ANALYSIS OF MOBIL/TVA'S INTERIM MINING AND
RECLAMATION PLAN FOR PILOT TESTING OF IN SITU LEACHING
AT CROWNPOINT, MCKINLEY COUNTY, NEW MEXICO, MAY 1978

June 19, 1978

MOBIL OIL CORPORATIONS

Damping rates were computed based on mutual drawdown interference.

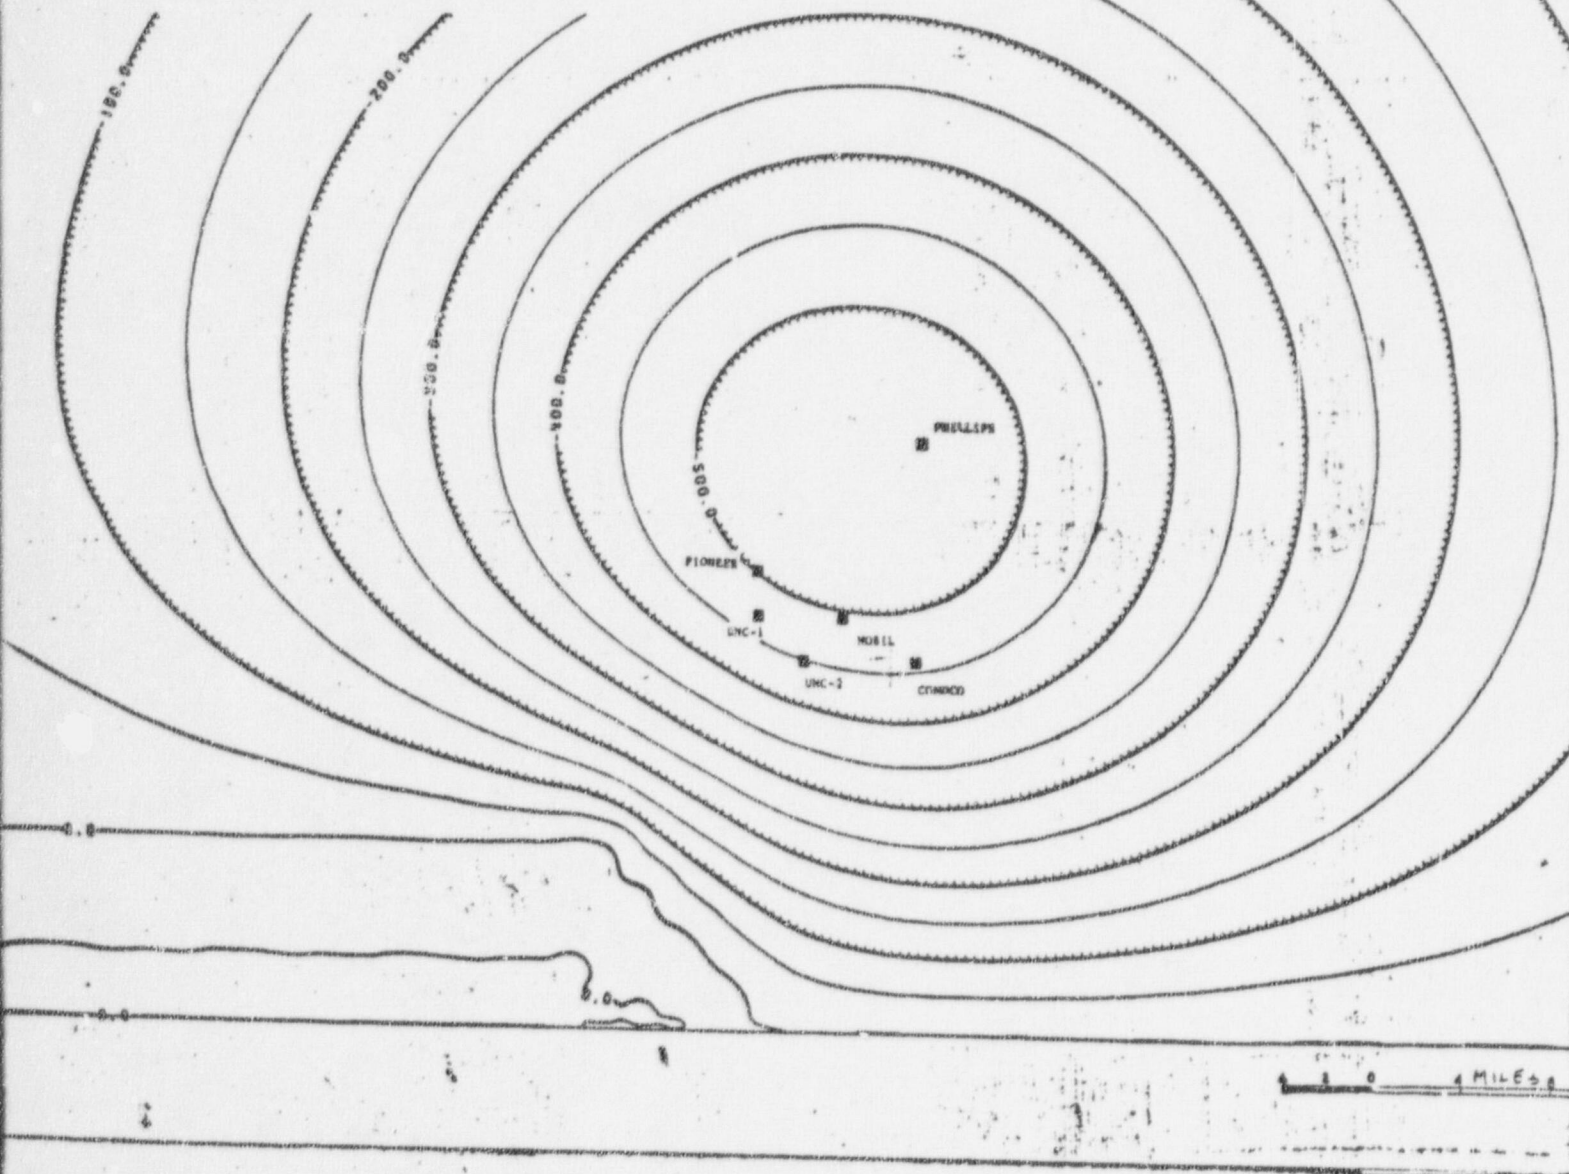
TVA has modeled the effects of the dewatering of six uranium mines (see Appendix B) -- those numbered 1, 3, 6, 7, 11, and 12 -- on page 3 of this paper. Given the seventeen mines listed on page 3, TVA's study clearly uses a low estimate of total dewatering impact. Still, this study shows major changes in the artesian head of the Westwater Canyon member. Drawdown of 1,300 feet at the in-situ site after 10 years of mine water discharge and 1,500 feet after 20 years of mine water discharge are projected. These maps from the TVA study are included as Appendix B.

The Mining Plan does not consider the impacts of these dewatering effects on the feasibility of in-situ uranium mining. The project has a 14-month production life and an 8-month restoration period. This 22-month period will be ending as the earliest projected southern San Juan Basin uranium mines begin reaching their ore zone and seriously affecting the hydrodynamics of the ore bearing zone. Thus the pilot project will occur mainly in a pristine aquifer and with full effects of dewatering being felt only as restoration -- the critical cleansing of the aquifer -- begins. The pilot project will not test "the waters" in the disequilibrium created by major mine dewatering withdrawals, which is the likely environment of any future in-situ leaching. The timing of the pilot project should be addressed by the Mining Plan.
